MINUTES OF MEETING: Thursday 10 May 2018
Meeting Room 5.16, NZTA Offices, Majestic Centre, 100 Willis St,

Decisions - AMIG 10 May 2018

1. Paired Pedestrian and Cycle Priority Crossing - TCD elements required for installing

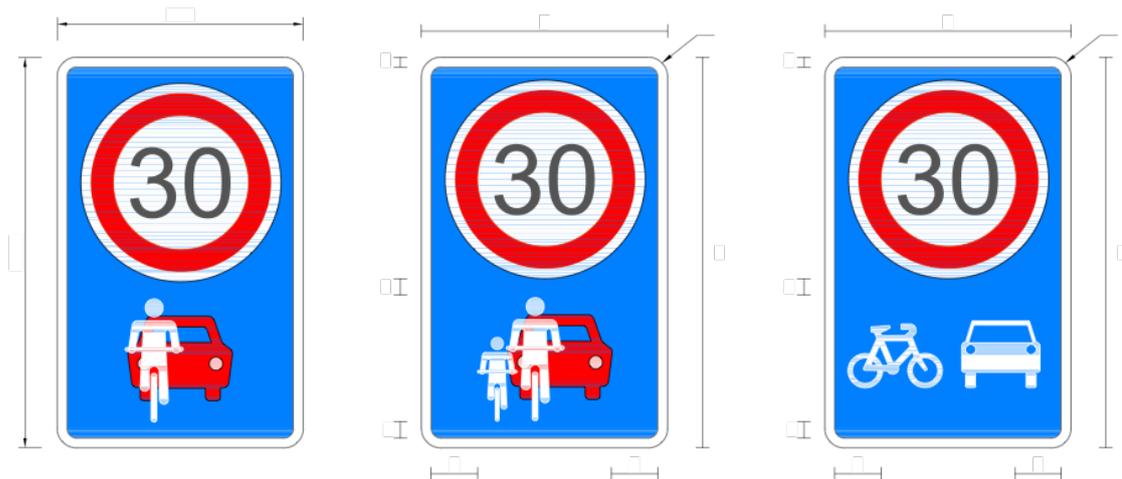
It was noted that the cyclist entered the road without looking or slowing and crossed on the pedestrian crossing, and that neither crossing is on a platform. The decision to install without a platform reflected strong opposition from the bus operator, as this is a bus route. It was agreed that the incident demonstrated that a platform was required and that the guidance should be more emphatic in requiring a platform; if the crossing cannot be put on a platform, it should not be installed.

It was also agreed that the incident indicated that the speed management was insufficient for the cyclist, with the sign to "look for traffic" ineffective, and the continuous green lane across the road giving visual cues that encouraged unsafe behavior. The green blocks used across vehicle entrances have been shown to be effective in slowing cyclists and encouraging caution. It was agreed that a trial of a "green and black zebra" should be undertaken.

2. A platform is required for a cycle crossing; if the crossing cannot be put on a platform, it should not be installed. Blocks of green rather than a continuous green lane across the road should be used to avoid visual cues that encourage unsafe behavior by cyclists. Green blocks used across vehicle entrances have been shown to be effective in slowing cyclists and encouraging caution.
3. The “pass with care” cyclist symbol (duplicated at reduced scale to indicate a child cyclist) superimposed on a car beneath a 30 kmph roundel is endorsed as the threshold sign for any 30 kmph low volume shared road space meeting the criteria for marking Sharrows, as it gives a stronger and clearer visual cue for the desired behavior:
